UNITED STATES PATENT AND TRADEMARK OFFICE

10/068,239

Office Action Summary	Application No.	Applicant(s)	
	10/068,239	O'NEILL, TERRENCE JOHN	
	Examiner	Art Unit	
	Jeanne-Marguerite Goodwin	2841

DETAILED ACTION

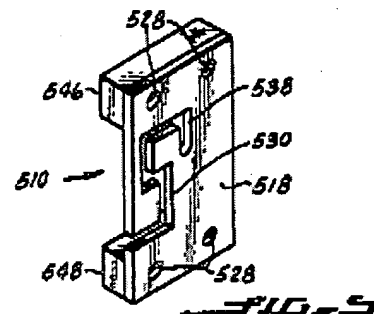
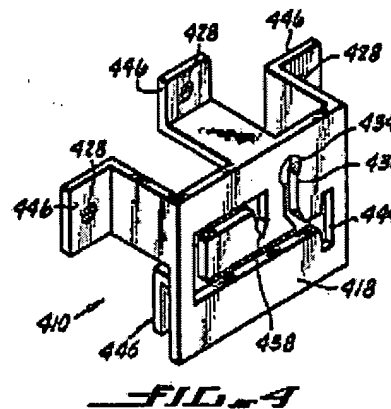
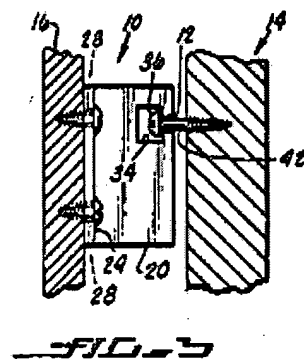
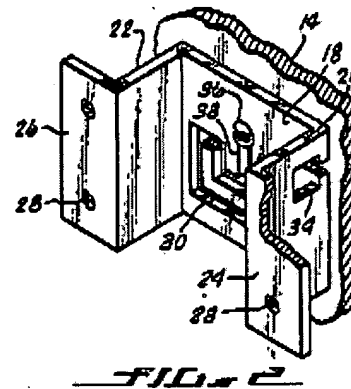
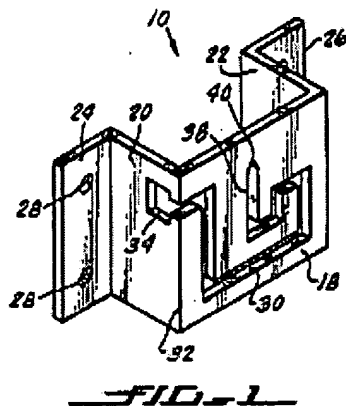
5. Claims 1-6, 19-31 and 34-42 are rejected under 35 U.S.C. 102(b) as being anticipated by US Patent 4,190,221 to Updike.

With respect to claim 1: Updike discloses a hanger for supporting a device, the

hanger comprising a housing having a face positioned substantially vertically; and a nonlinear slot cut into the face, the slot having a first end and a second end, the first end being closed and the second end being opened (see figure below).

With respect to claim 2: Based upon the Applicant's figures, Updike's discloses a hanger, wherein the hanger includes a protrusion movable along the slot, wherein movement of the protrusion along the slot from the second end toward the first end is substantially unimpeded, and wherein during movement of the protrusion along the slot from the first end toward the second end, the protrusion is selectively movable along the slot branches slot branches to impede movement of the protrusion along the slot toward the first end (see figure above).

With respect to claim 3: Updike's slot has a substantially constant width (see figure above).

With respect to claim 4: Updike's slot makes at least one change of direction of greater than 45 degrees (see figure above).

With respect to claim 5: Updike discloses a hanger for supporting a device, the hanger comprising a face lying in a substantially vertical plane positioned substantially vertically and at least partially defining a receiving area, a substantially vertical slot cut into the face, the slot having a first end and a second end, the first end being closed and the second end opening into

the receiving area, and at least one substantially vertical slot branch extending from the slot at an acute angle and having a closed end, the at least one slot branch having a substantially constant width that is substantially the same as the width of the slot (see figure above).

path for the projection, an exit path for the projection, and at least one locking path for the projection, the locking path being different than the exit path (see figures above).

With respect to claim 26: Updike discloses the hanger of claim 19, wherein the slot includes an opened end, a first closed end, and a second closed end, and wherein the locking path extends between the first closed end and the second closed end (see figures above).

With respect to claim 30: Updike discloses the hanger of claim 19, wherein at least a portion of the locking path defines an acute angle with respect to at least a portion of the exit path (see figures above).
